Comment #36, #37: Autocorrelation of PRBS13Q

IEEE P802.3bs 200GbE and 400GbE Task Force
San Antonio, November 7-9, 2016

Comment #36 (with updates)

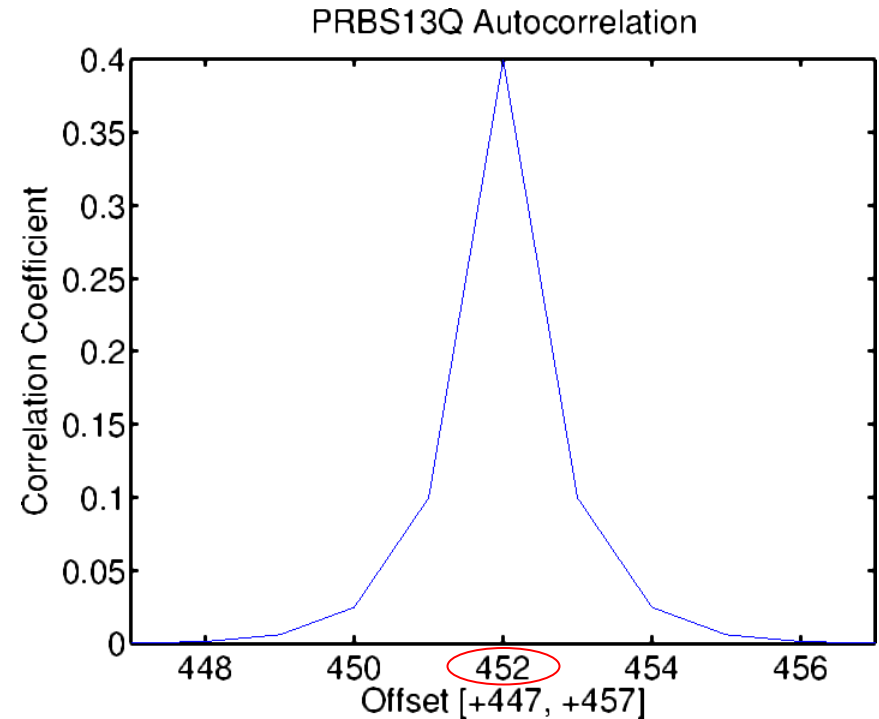
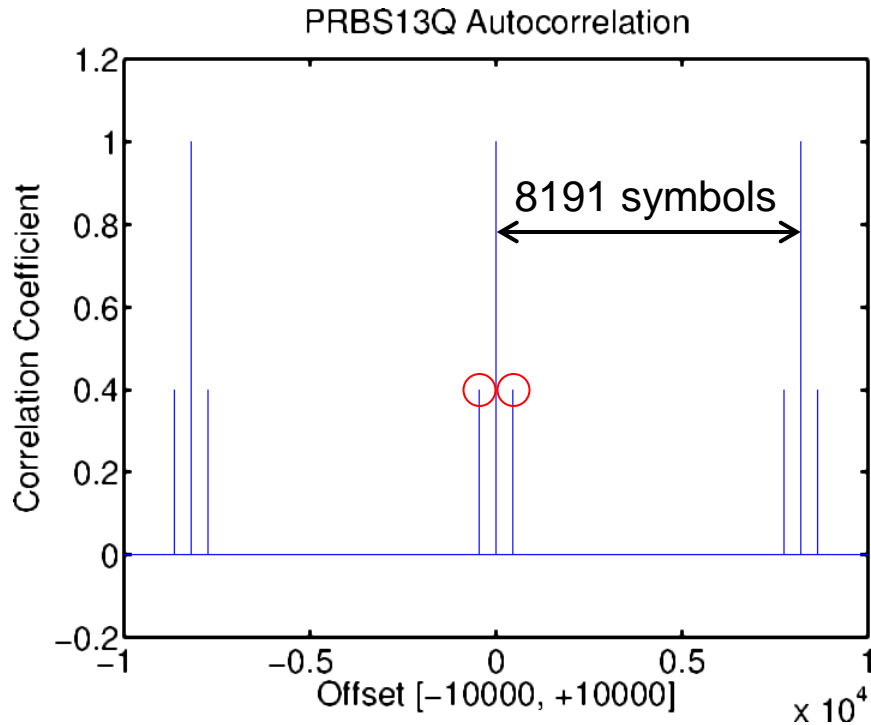
- Unlike PRBS31Q, PRBS13Q does not specify the seed for each lane or the minimum offset between PRBS13Q on different lanes. The Autocorrelation function of PRBS13Q has a strong peak at an offset of 452 symbols with correlation coefficient of 0.4. Lack of specification of seed for each lane or the minimum offset between lanes may result in strong correlation between test patterns on different lanes that is not desired for measurement accurately. It is also discouraged to reuse 4 seeds in Table 94-11 by adding 4 more seeds, because they will make the offset between Lane 1 and 2 only 827 symbols that is not sufficient to separate the strong peak between lanes. Autocorrelation function of PRBS13Q is almost flat for an offset between 470 symbols and 7720 symbols.

- Unlike PRBS31Q, PRBS13Q is not specified with the seed for each lane or the minimum offset between PRBS13Q on different lanes.
- Lack of specification of seed for each lane or the minimum offset between lanes may result in strong correlation between test patterns on different lanes that is not desired for accurate measurement.
- We may reuse Table 94-11 that has 4 seeds by adding 4 more seeds, but it is not clear if we can get large enough offset using the seeds in Table 94-11.
- Hence, I studied the autocorrelation function of PRBS13Q and the offset with 4 seeds in Table 94-11.

- Also specify the minimum offset of 940 symbols between PRBS13Q patterns between any lane and any other lanes in Clause 120.5.11.2.3.

Autocorrelation function of PRBS13Q (1/2)

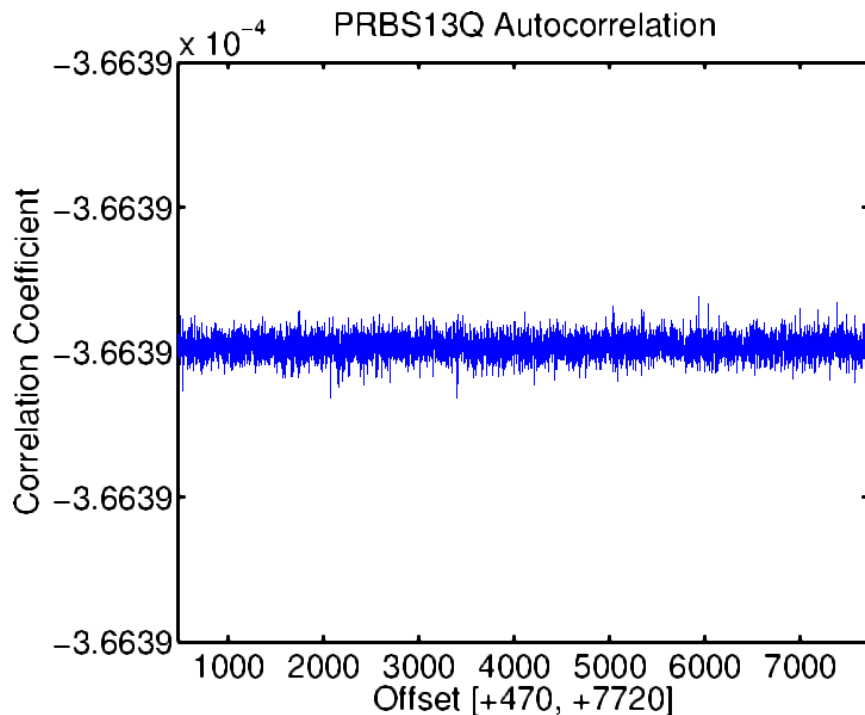
- Autocorrelation function of PRBS13Q is a periodic function with a cycle of 8191 symbols (i.e. length of PRBS13Q)
- It has a strong peak at an offset of ± 452 symbols with correlation coefficient of 0.4.

- Autocorrelation function of PRBS13Q has flat correlation coefficient about -3.6639×10^{-4} with an offset from 470 symbols to 7720 symbols

Offset between lanes with seeds in Table 94-11

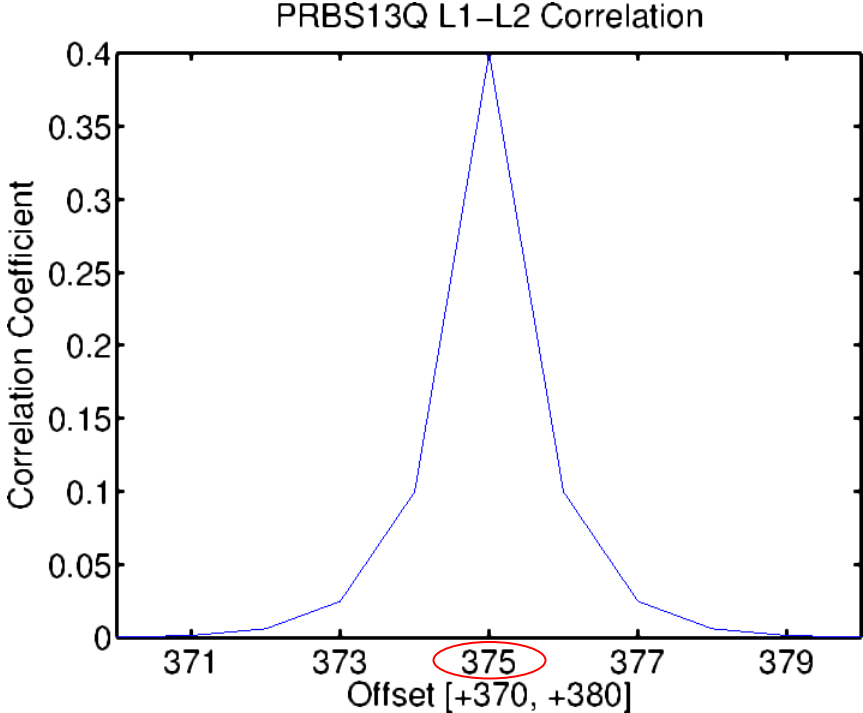
- Offset between L1 and L2 is only 827 symbols
 - It brings the strong peak of the adjacent lane closer than its own
 - The offset to the strong peak in the adjacent lane is 375 (=827-452) symbols
 - It is closer than its own peak at the offset of 452 symbols

- It is recommended to specify PRBS13Q pattern has a minimum offset of 940 ($=470 \times 2$) symbols between any lane and any other lane.
- It is discouraged to reuse 4 seeds in Table 94-11 by adding 4 more seeds, because they will make the offset between L1 and L2 only 827 symbols which brings the strong peak of the adjacent lane closer than its own.

Offset between L1 and L2 using Table 94-11

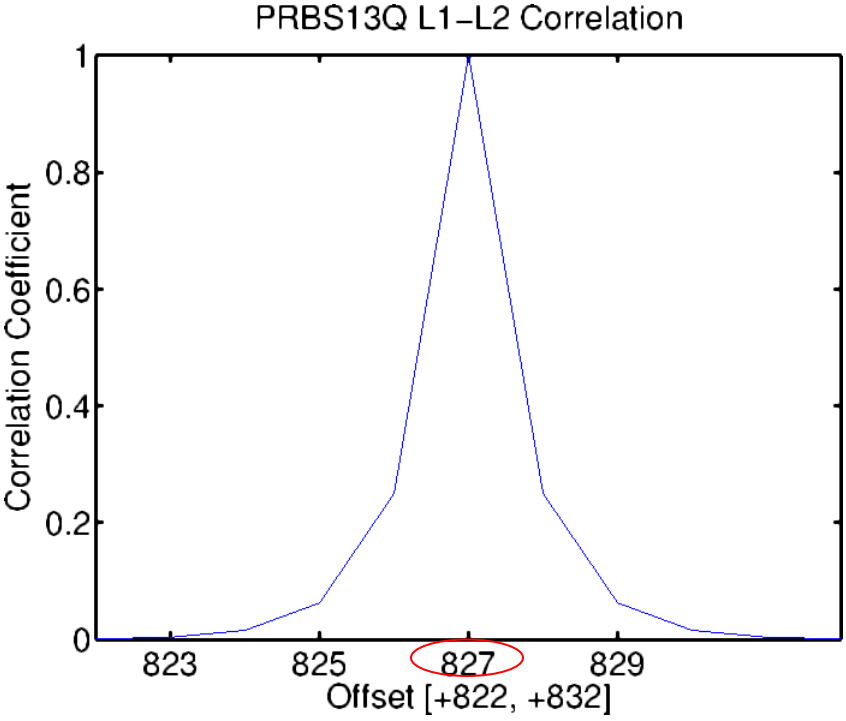
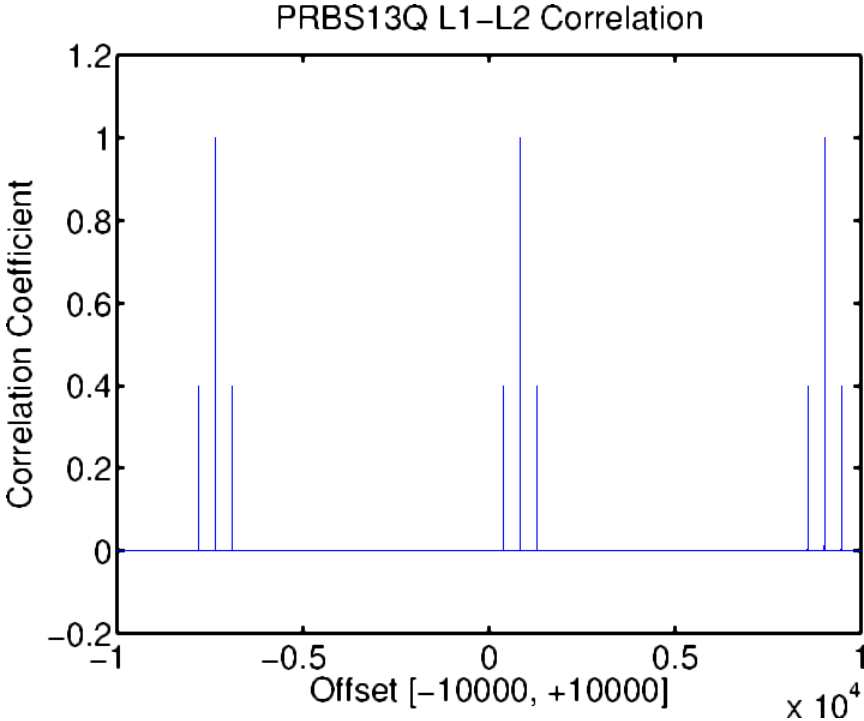
- The offset between Lane 1 and Lane 2 is 827 symbols.
